**PLANNING COMMISSION STAFF REPORT  
MAJOR SUBDIVISION SMF2023 0002  
HEARING DATE: AUGUST 22, 2023**

**PROPOSAL:** Applicant requests a Final Plat review for shared access subdivision of Tract A into four (4) lots, with access via Kristi Street.

**Project Description** – The Applicant requests a Final Plat review for shared access subdivision of Tract A into four (4) lots, with access via Kristi Street (**Attachment A**).

SHARED DRIVEWAY B  
PLAN VIEW

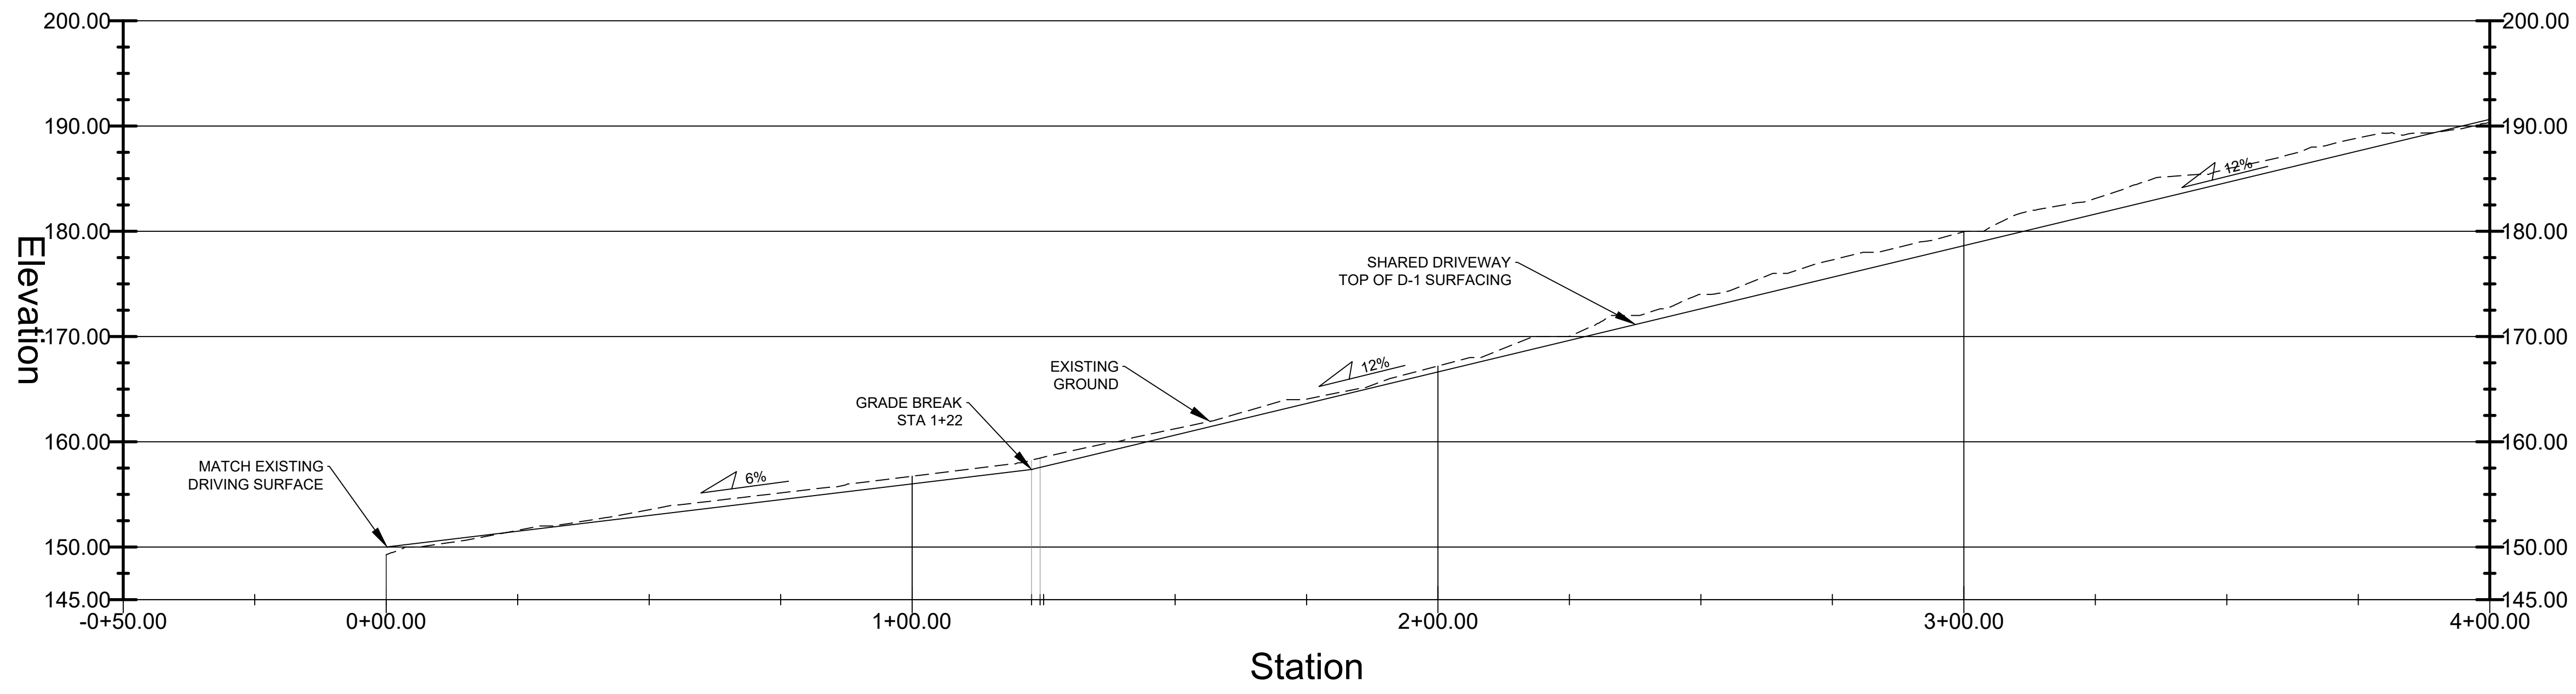
**A CULVERT WITH HEADWALL IS SHOWN ON SHEET 5 OF THE CONSTRUCTION DRAWINGS. WHILE THIS DOES NOT GET THE WATER BEYOND THE ROCK WALL, IT DOES PREVENT WATER FROM GOING IN THE SHERRI ST DITCH – WHICH IS A PRIMARY REQUIREMENT.**

**THIS IS ACCOMPLISHED WITH THE CULVERT SHOWN ON SHEET 5.**
    - ii. Culvert sizes and entry losses with existing culverts – primarily Sherri St and Wee Burn Dr. **THIS IS UNDERSTOOD – PART OF THE REASON IS THAT THE CULVERTS WERE NOT REQUIRED TO HAVE HEADWALLS WHEN BONNIE BRAE WAS CONSTRUCTED.**

## SHARED DRIVEWAY A DRAINAGE SCHEMATIC

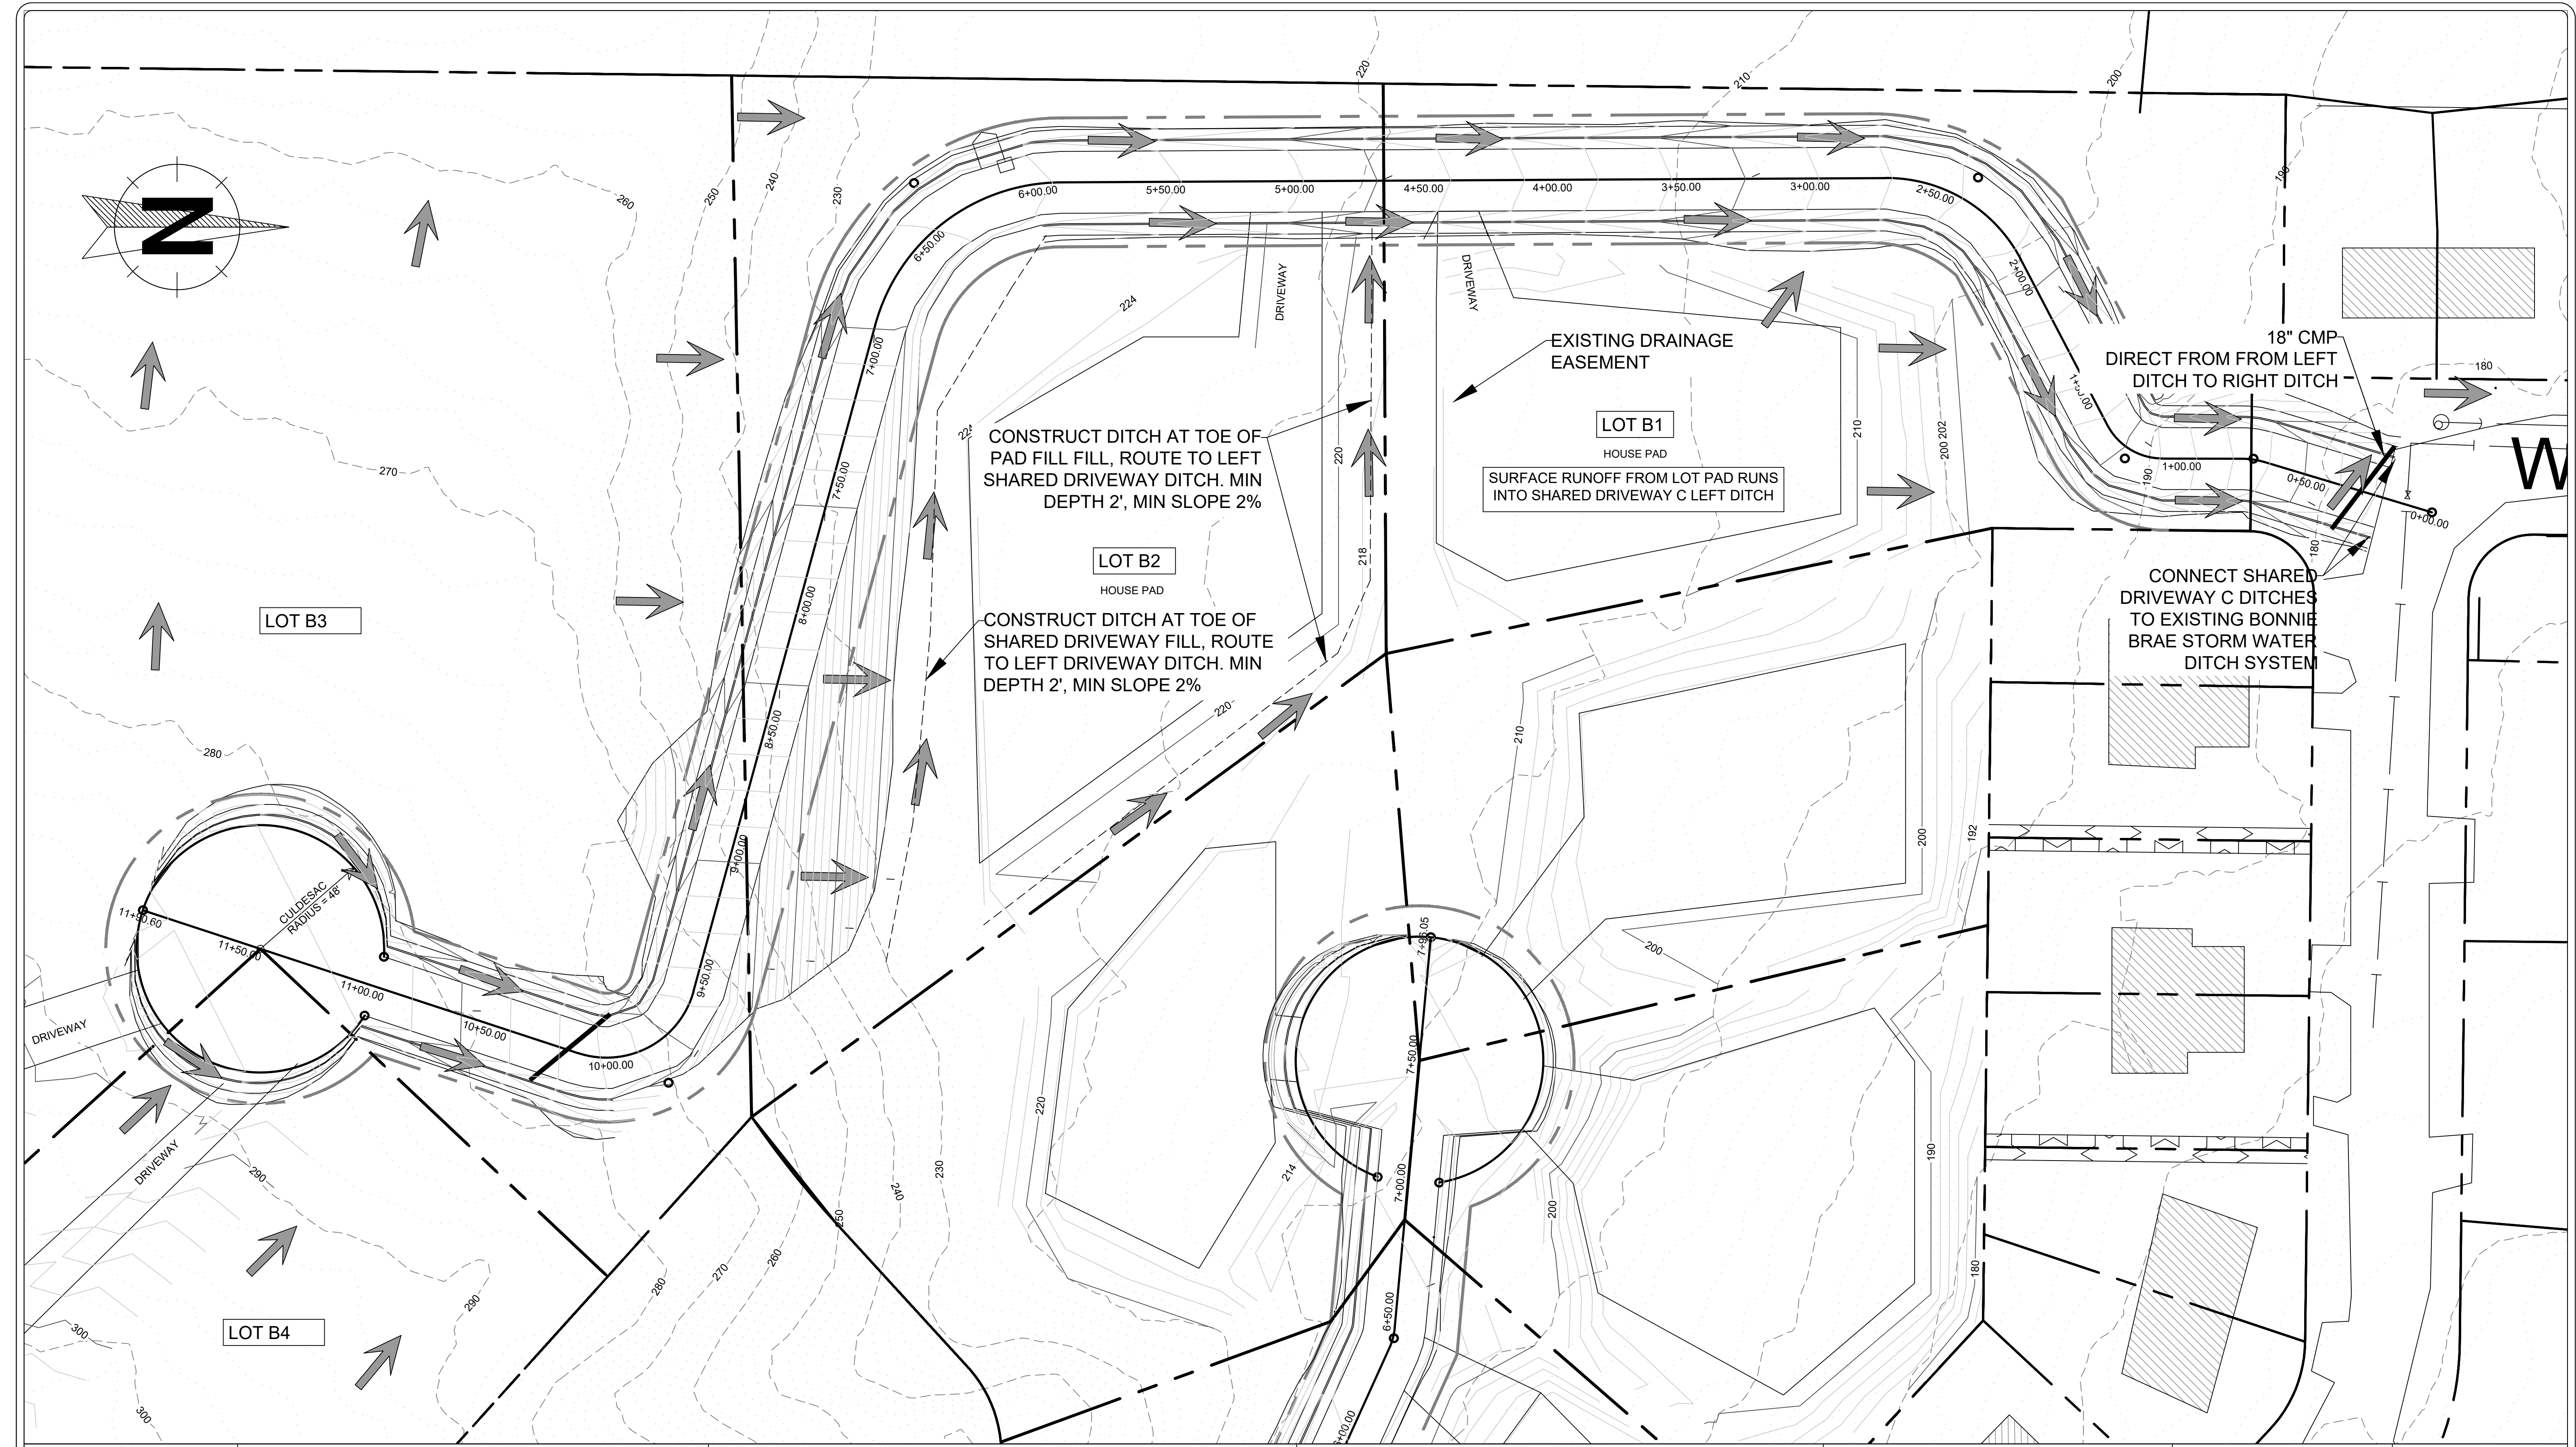
As a followup to the culvert replacement- the driveway culverts for 6721 & 6713 require new 18" culverts to be installed. There is an existing note on sheet 14 that states this generic requirement, so I won't issue a revised construction drawing set.

### ENGINEERING

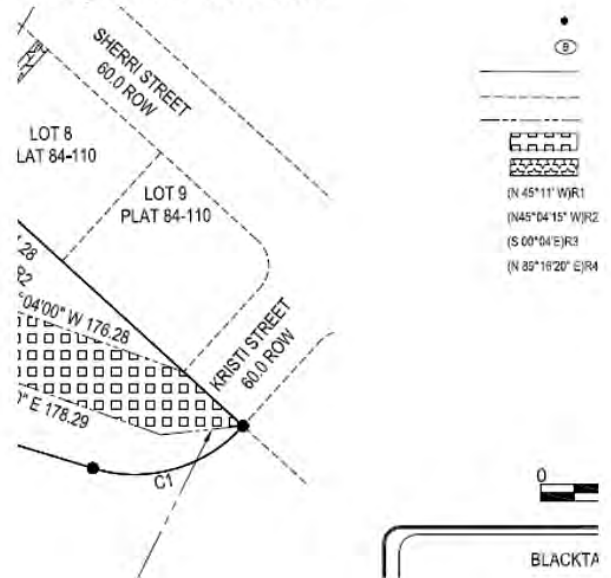
1. Recommended. Maintain the approved 60' radius (C5) easement alignment as indicated below.

### CARTOGRAPHY

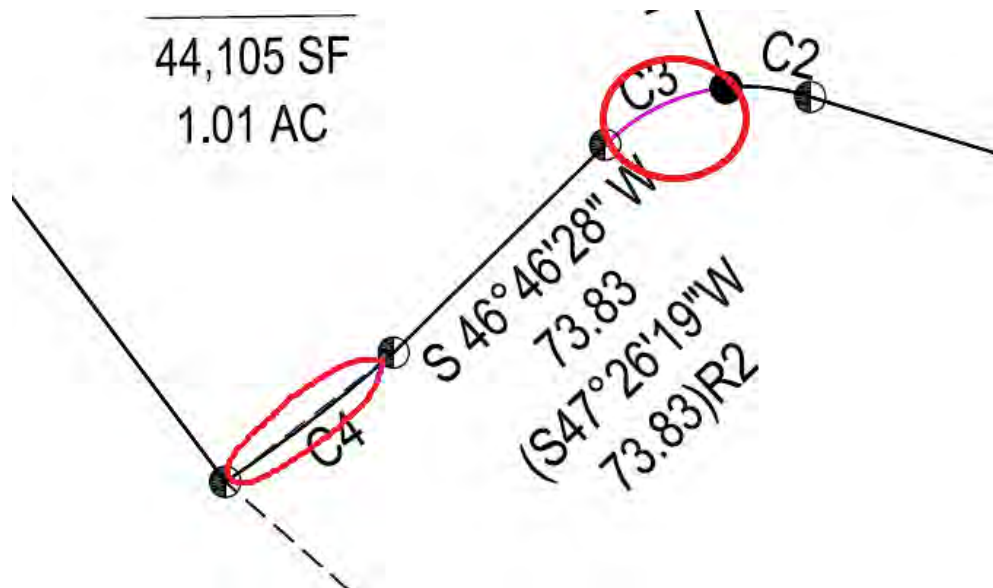
5. Use a consistent bold line type for the surveyed lot lines and match the symbol in the legend.
6. Delete the dashed line identified below and revise the pink segment to black.

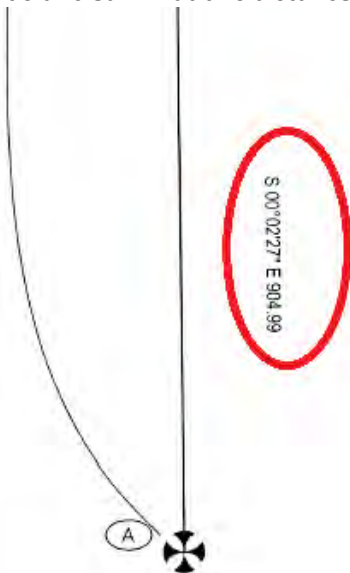
- i. Use this access note for private shared access subdivisions (CBJ49.35 DIVISION 2) (i.e. access to 1 or more lots is via an easement and some lots have no right of way frontage)

ACCESS SUBJECT TO CBJ 49.35 ARTICLE II DIVISION 2 'PRIVATE SHARED ACCESS' REQUIREMENTS. ACCESS TO [LOTS X, Y, and Z] SHALL BE RESTRICTED TO A SINGLE DRIVEWAY IN THE SHARED ACCESS EASEMENT. USE OF THE ACCESS EASEMENT DELINEATED ON THIS PLAT IS SUBJECT TO THE REQUIREMENTS SET FORTH IN THE [COMMON DRIVEWAY ACCESS, UTILITY AND MAINTENANCE AGREEMENT – edit title as appropriate] RECORDED WITH THIS SUBDIVISION.

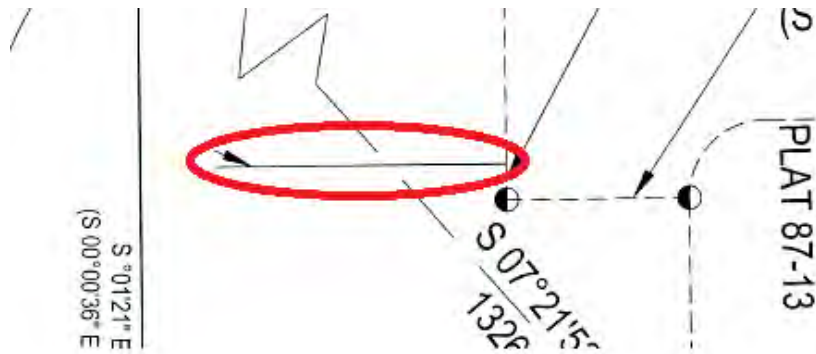
10. Delete arrow and revise line type to un-surveyed.

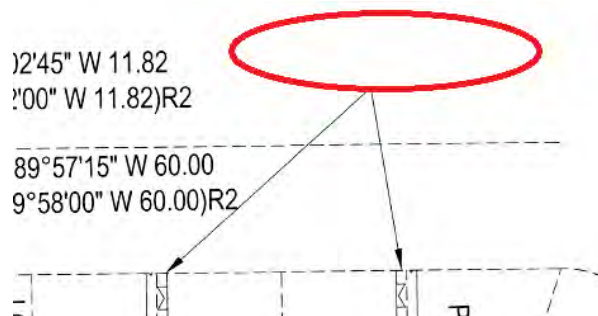
11. Easement annotation is missing.

12. Revise to unsurveyed line type.
